CONTRACT Change ORDER NO.8

DATE: 5/18/2026

PROJECT: Lake County Sheriff's Administration Renovation  
 Project No. 250816

|                        | Cooling     | Heating     |

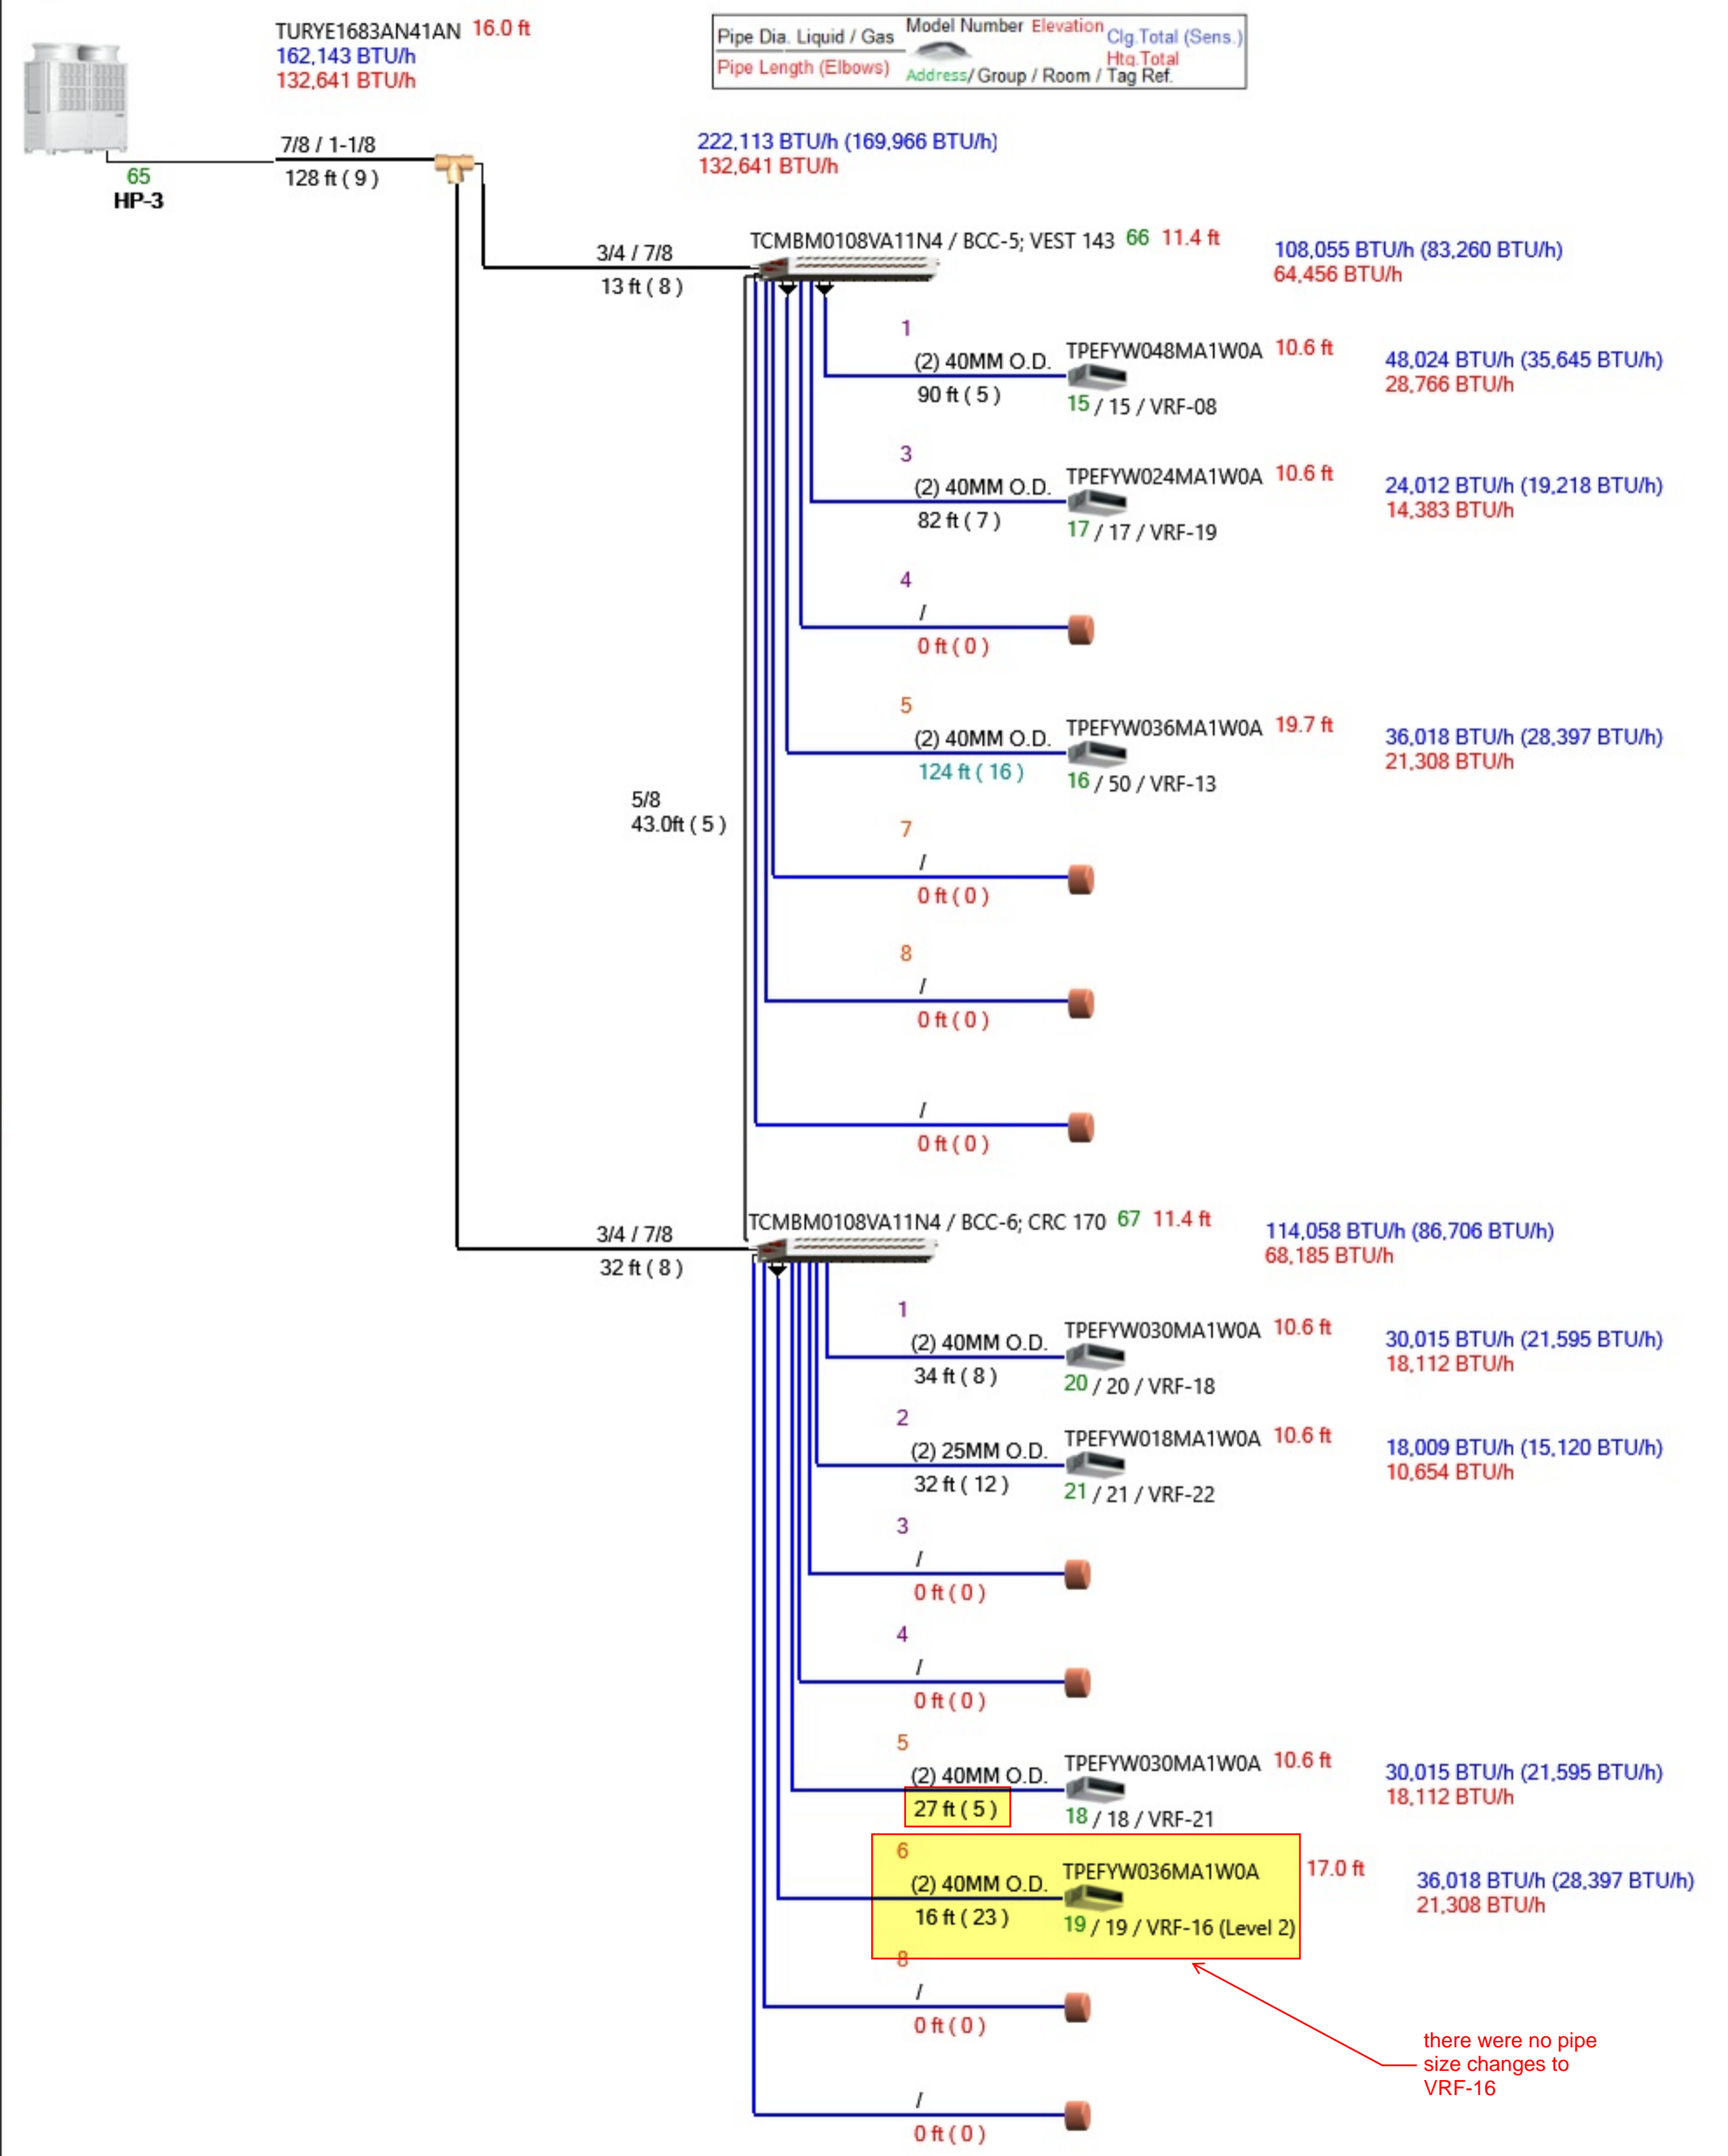
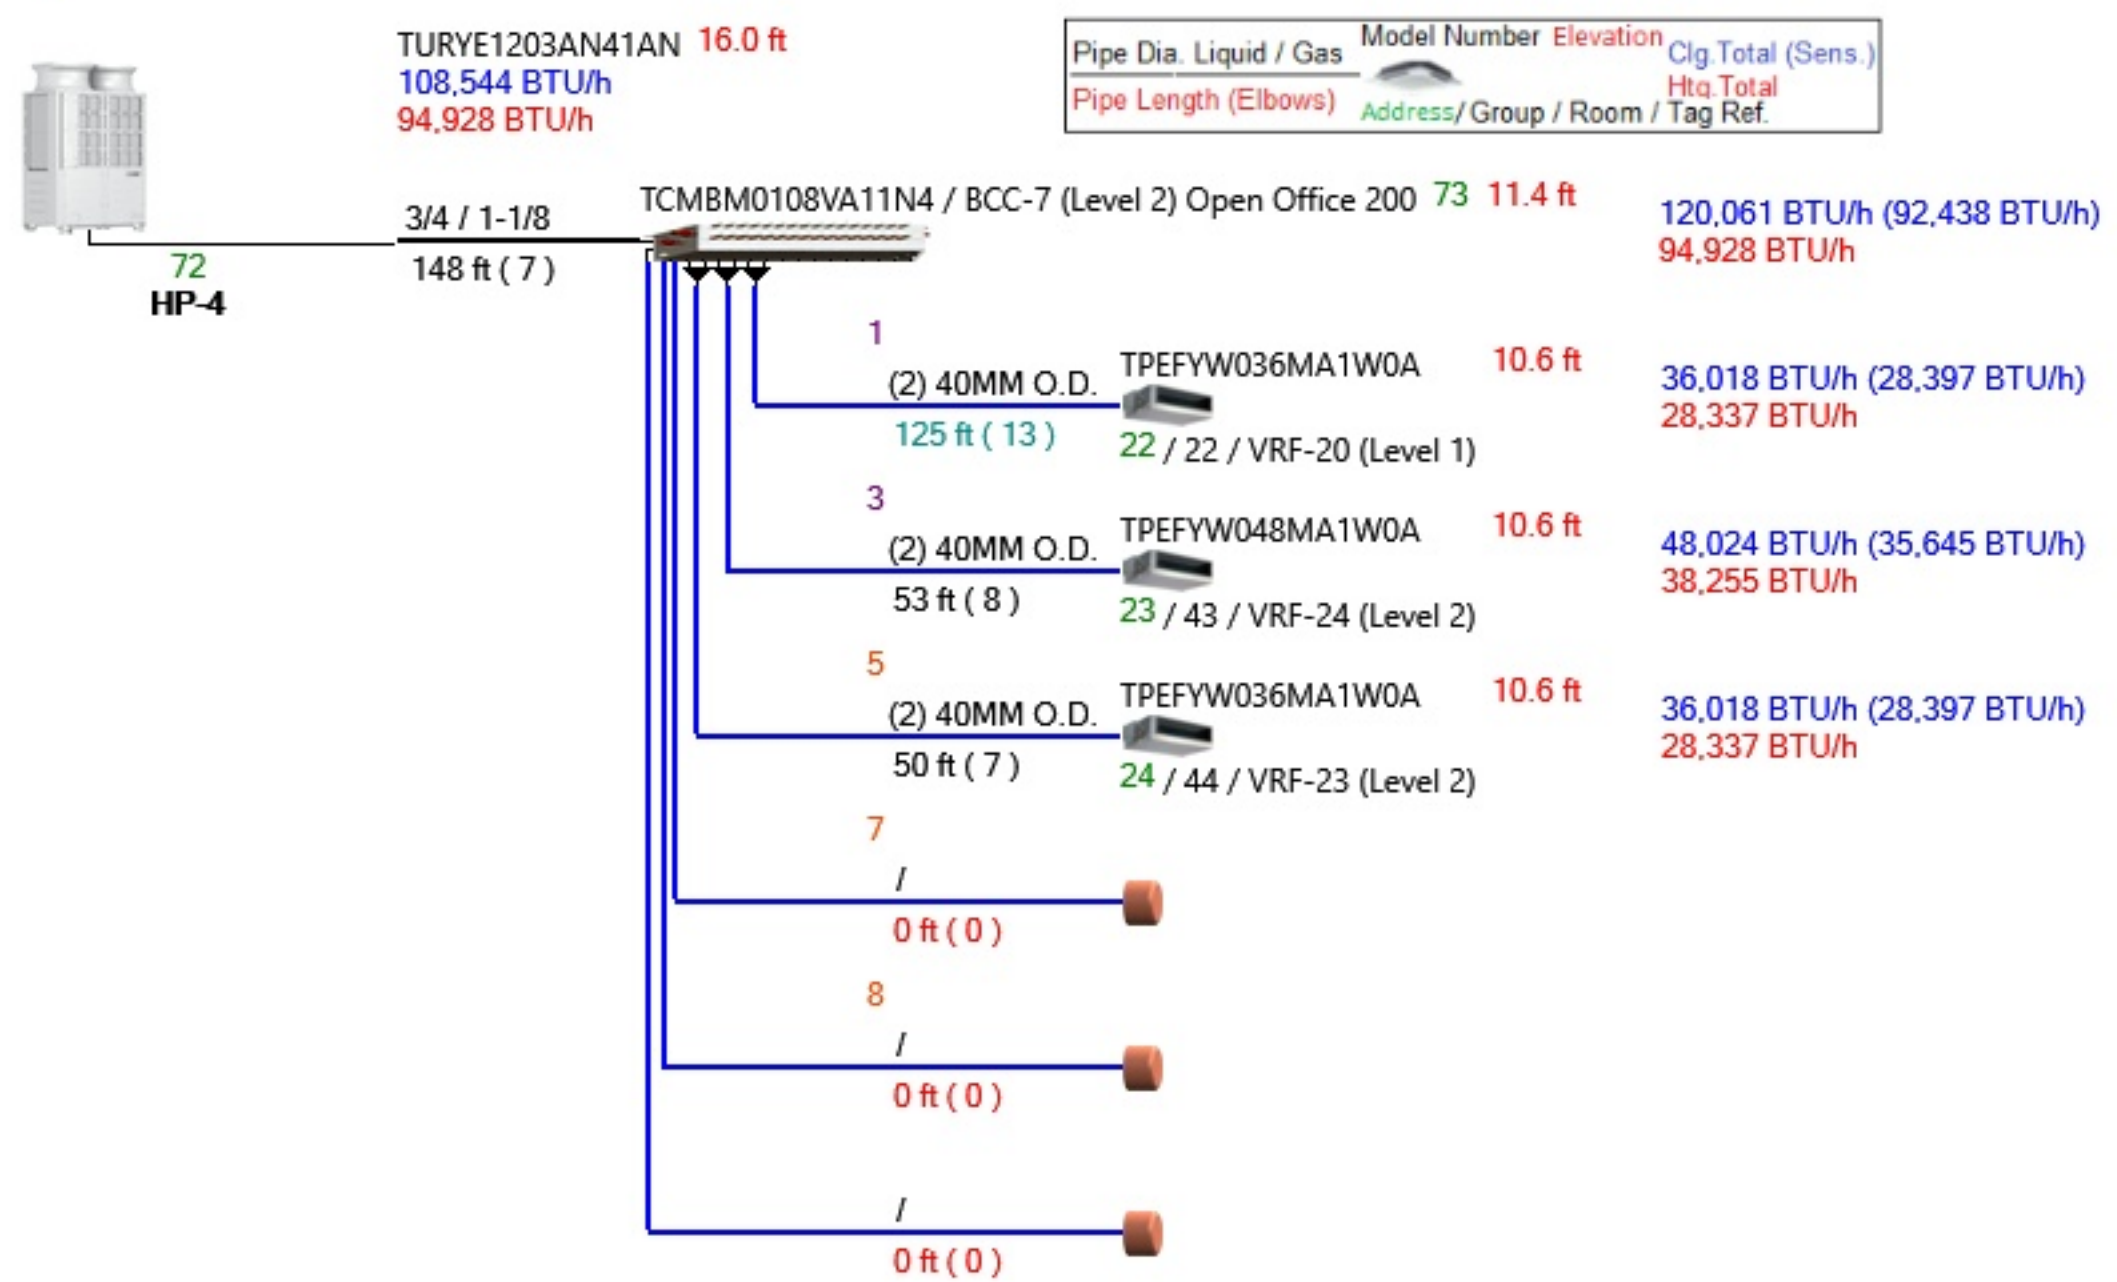
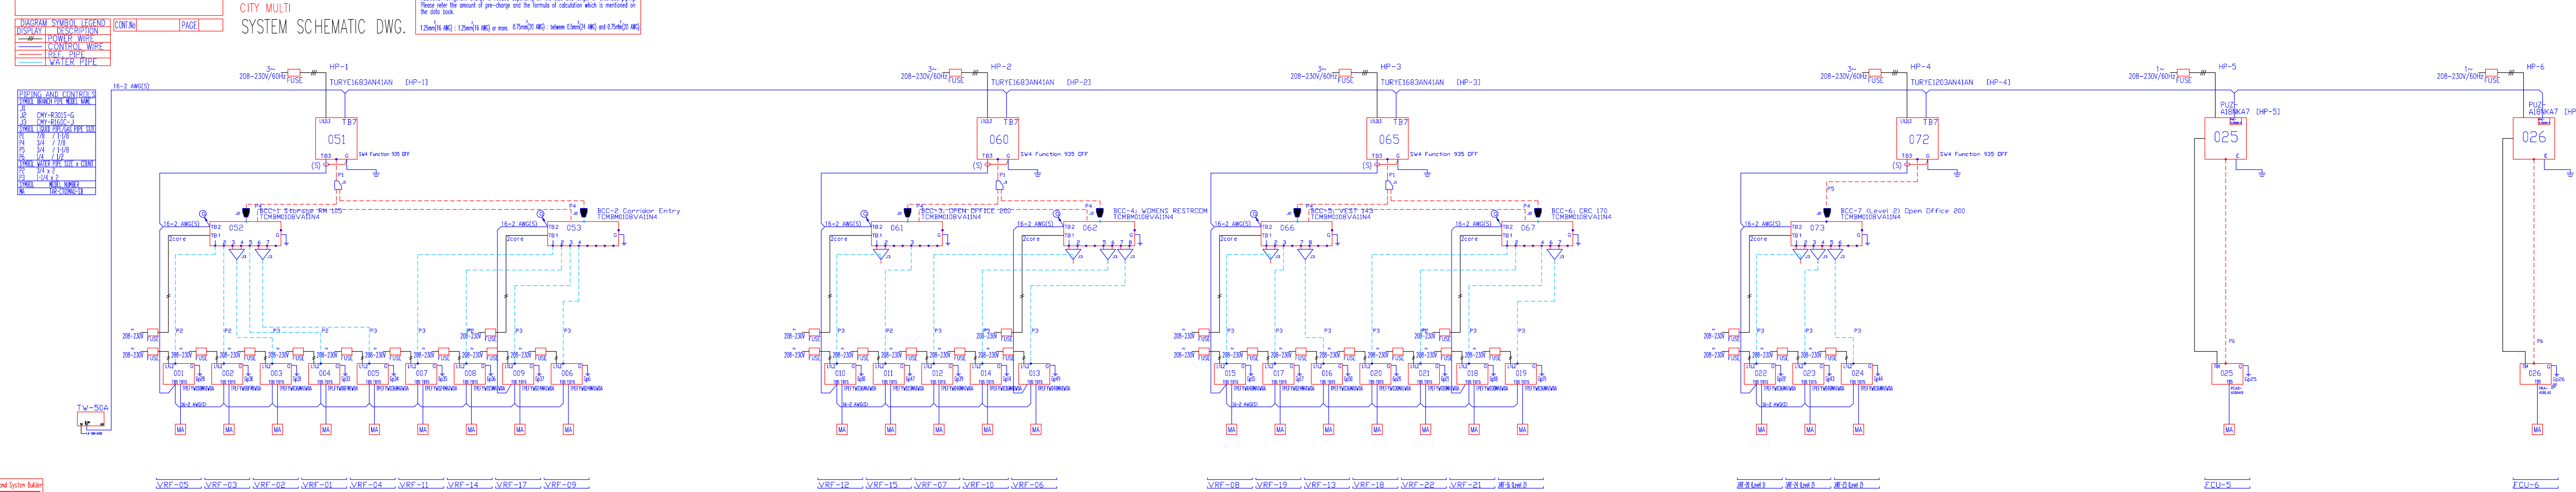
| Name                                | Type                          | Description   | TOTAL               |
|-------------------------------------|-------------------------------|---|---------------------|
| Design Revisions                    | HP-3 Piping Reconfiguration   | HP-3 is currently at maximum capacity. To ensure proper system performance and hydronic flow, piping at BC-5 and BC-6 will need to be reconfigured to accommodate the required capacity.  |                     |
| VRF-8 & VRF-13                      | Re-Port at BC-5               | Need to Twin VRF-8 to Port 1&2 at BC-5 and twin VRF-13 to Ports 5&6 at BC-5. Scope: Cut in each line and add T's and elbows and braze in to the Ports that Trane suggested. 1 T needed for each VRF and 3-4 elbows, with about 3ft +/- of copper for each VRF along with Insulation, and Insulation elbows.     | \$ 527.42           |

RFI-172 does not mention any required piping changes to VRF-16.

DOOR SCHEDULES, ELEVATIONS, AND DETAILS PROJECT NO. 50164453 SHEET NO. A-601

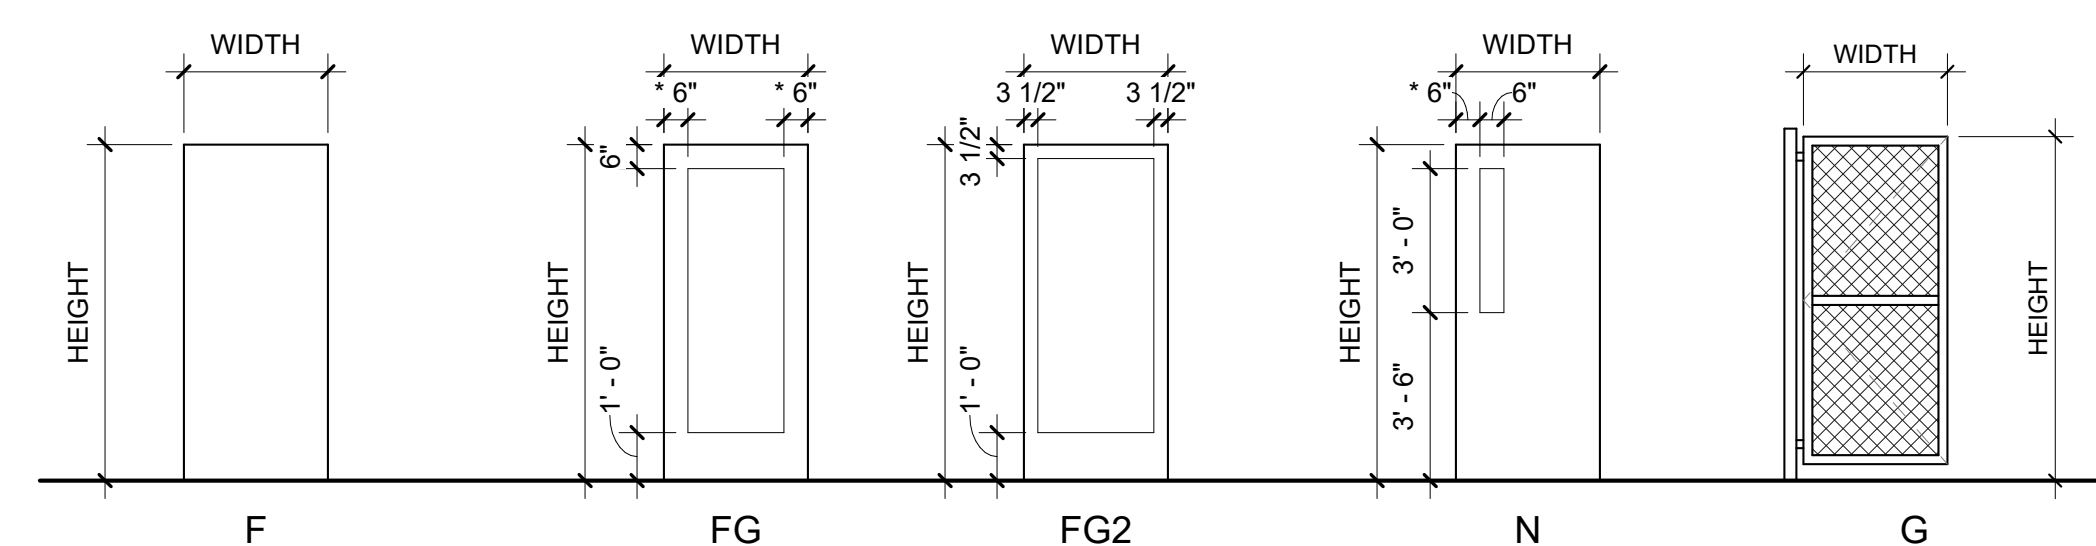
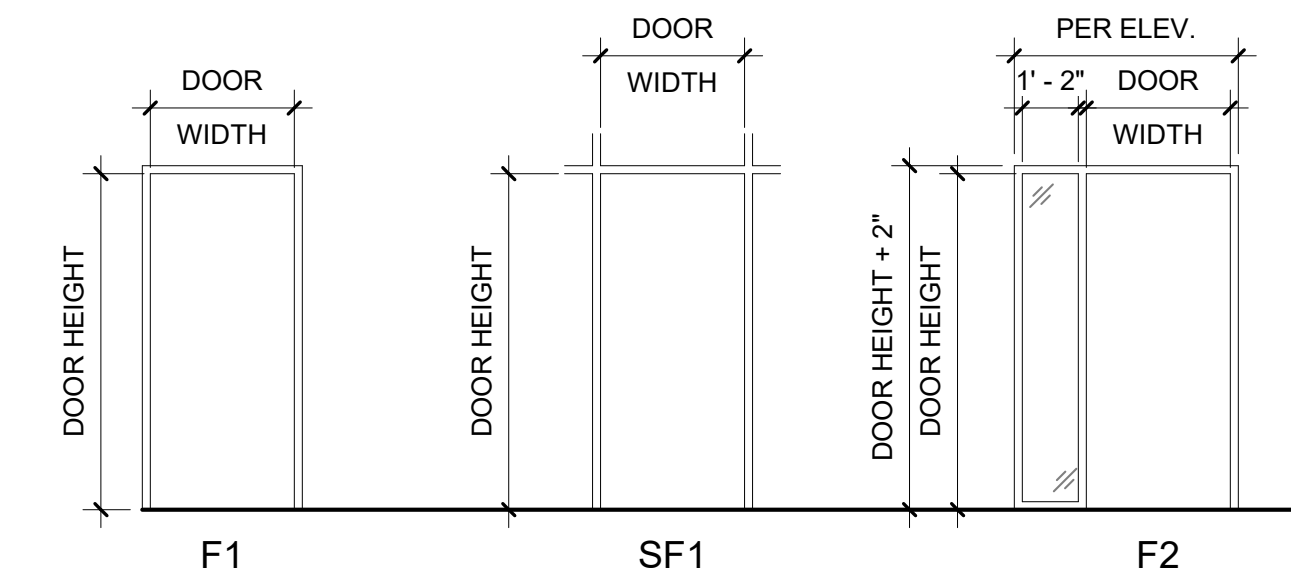
Hardware change due to ASI 10. Door 147A changed to Hardware group 19, Door 172 changed to Hardware group 3 and Door 200A&B changed to new Hardware group 7.1. Additional Labor added due to new electrical hardware added as well as additional hardware added to doors when group number changed. Original plans stated to reuse hardware for groups 25 and 26.
